RANCHO SANTIAGO COMMUNITY COLLEGE DISTRICT

ADDENDUM NO. 01

**Bid #1487 BUILDING D ACCESS CONTROL
at
SANTA ANA COLLEGE**

Project ID #3193, DSA #04-121892

SECURITY RISER
DIAGRAM

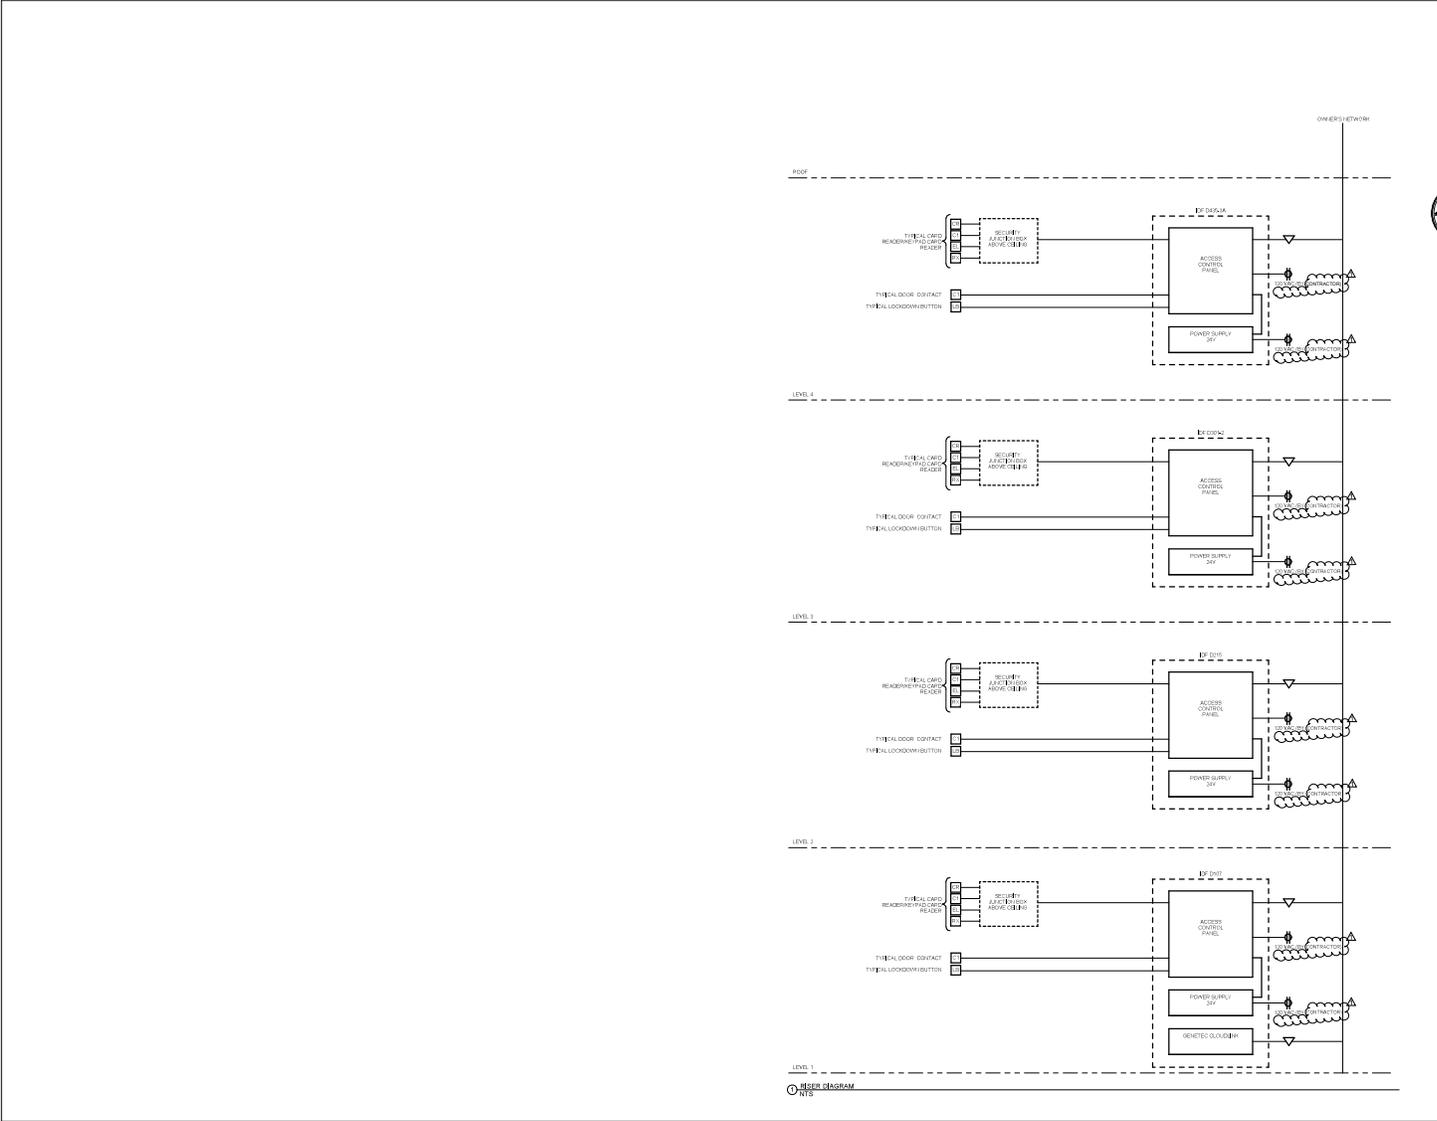
1. SHEET SE0-0, SECURITY SYMBOLS, GENERAL NOTES AND ABBREVIATIONS:
 - a. Revise: Security Legend – Back box and Conduit responsibility has been revised from “BY OTHERS” to “BY CONTRACTOR.”
 - b. The architect’s stamp is added to this sheet.
2. SHEET SE5-2, SECURITY DIAGRAM:
 - a. Revise: The 120 VAC power previously noted as “BY OTHERS” has been revised to “BY CONTRACTOR”.
 - b. The architect’s stamp is added to this sheet.
